Report to the Future Melbourne (Planning) Committee

**Ministerial Planning Referral TPD-2010-37/A
Collins Wharf, Victoria Harbour, Docklands**

PLANNING REPORT

MINISTERIAL REFERRAL

Image 8. Building heights and tower separation

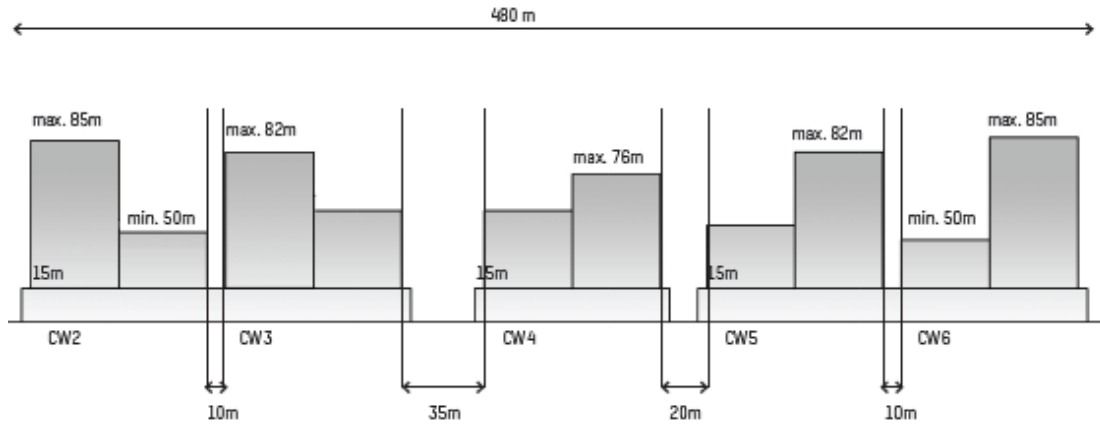
- Further details regarding tower design principles and materiality are required
- A tower separation of 8m is of concern and unlikely to be supported. A minimum 10m tower separation is sought in combination with design principles promoting appropriate view lines and orientations between apartments.
- Indicative tower floor plans should be provided to ensure an appropriate level of amenity.
- Additional activation is required at the podium interface to Central Park and Eco Park. At a minimum it is expected that the end apartments in these locations will wrap around the corner (necessitating the removal of some car parking in these locations).

Image 12. Southern boardwalk (Yarra Walk) typical section under 2015 Development Plan

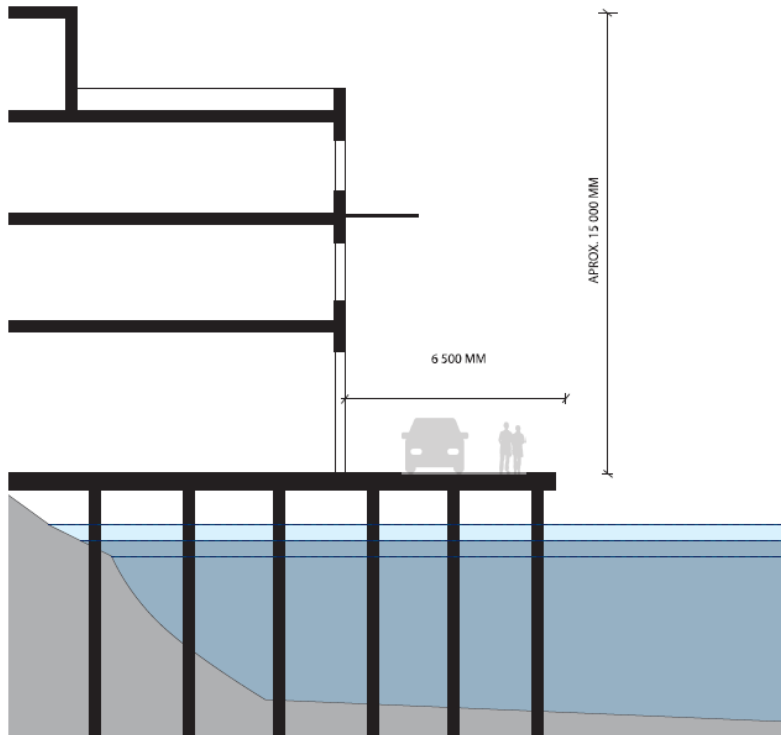
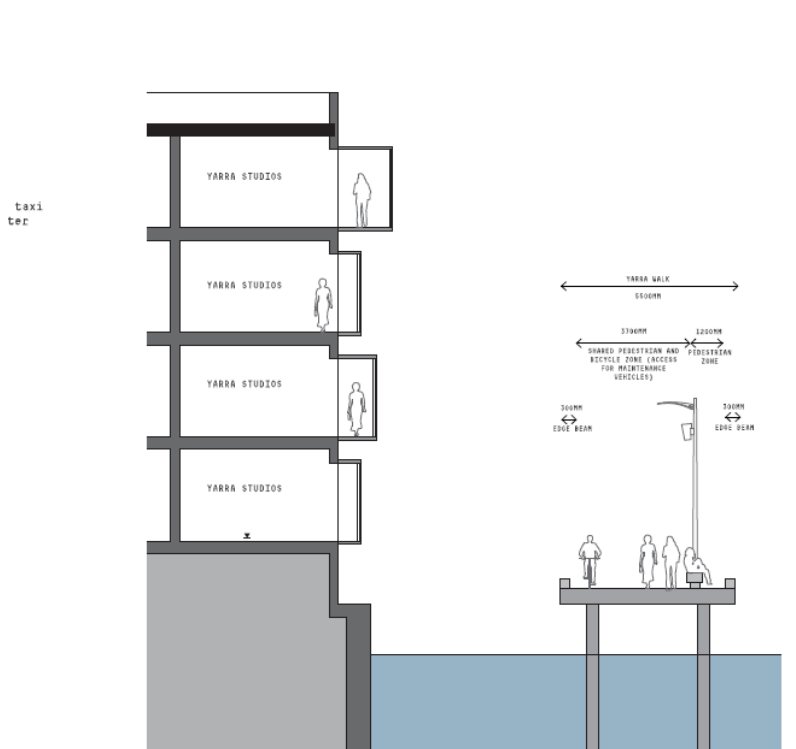
The altered design of the southern promenade, referred to as Yarra Walk, will provide a strong water focus and a high degree of public accessibility to the water. While the redesign of Yarra Walk over the water is a change in waterfront public typology as rolled out elsewhere in Docklands, it is considered acceptable in this location given the uniqueness of the wharf structure within Docklands. A different design for moving along the water adds to a diversity of public realm and user experience in Docklands.

Practically, Yarra Walk will continue to be a shared zone for cyclists and pedestrians and also provide access for small service vehicles limited to a proposed 10km/h speed limit. It extends the full length of the southern face of Collins Wharf, providing direct access to Eco Park at the westernmost tip of the wharf. It will also maintain flexibility for future berthing of commercial vehicles.

Image 13. 2010 Development Plan cross section

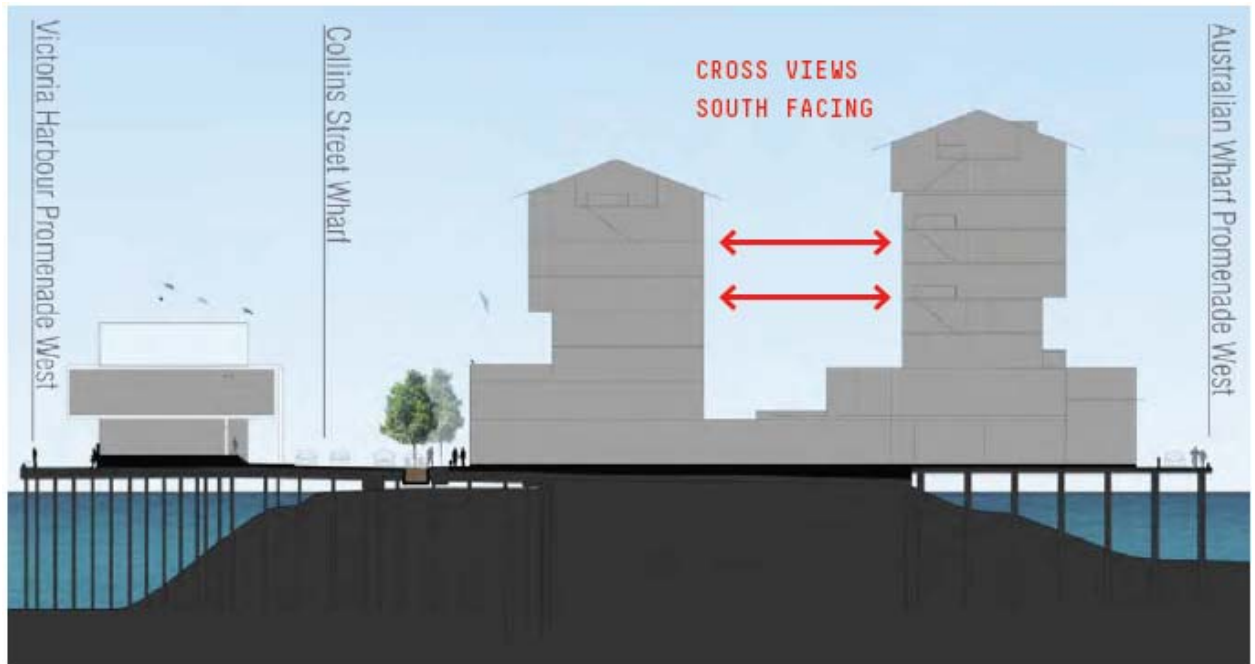
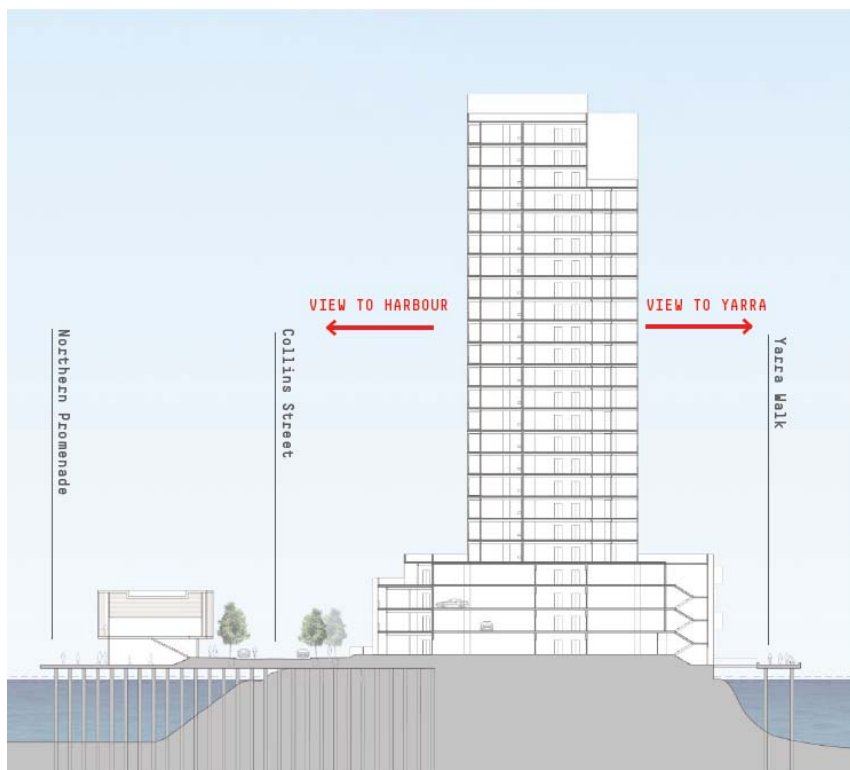
- As evidenced by images 13 and 14 below, the amended built form would significantly increase the vistas to the water (both Victoria Harbour and the Yarra River) for occupants of the buildings, substantially improving the internal amenity offered within the residential apartments;

Image15. Overall tower setback approach along Collins Wharf

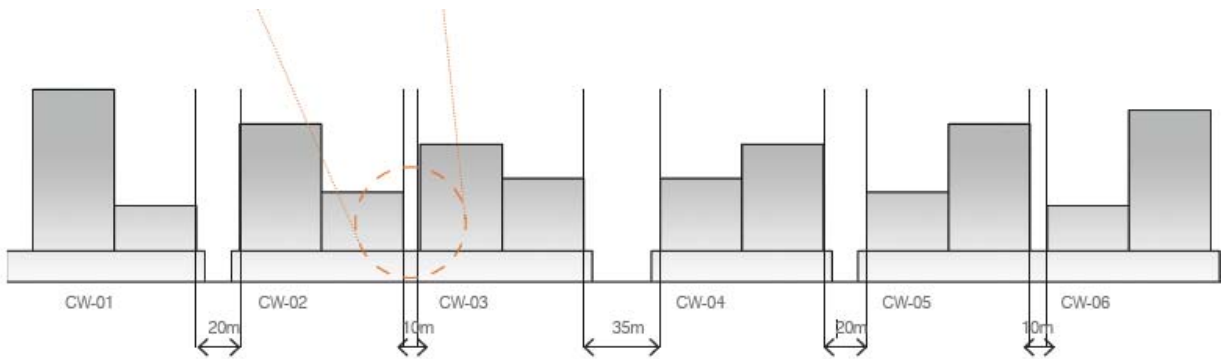
- While there are no tower setbacks specified under the Planning Scheme for development in Docklands, the 2015 Development Plan has nonetheless adopted the generally accepted minimum setbacks between towers of 10m, with setbacks from Yarra River to the south and Collins Street to the north to

act as podiums. The setbacks between the towers will allow sufficient separation between them for daylight and sun penetration to the public realm and avoid a continuous wall of towers.
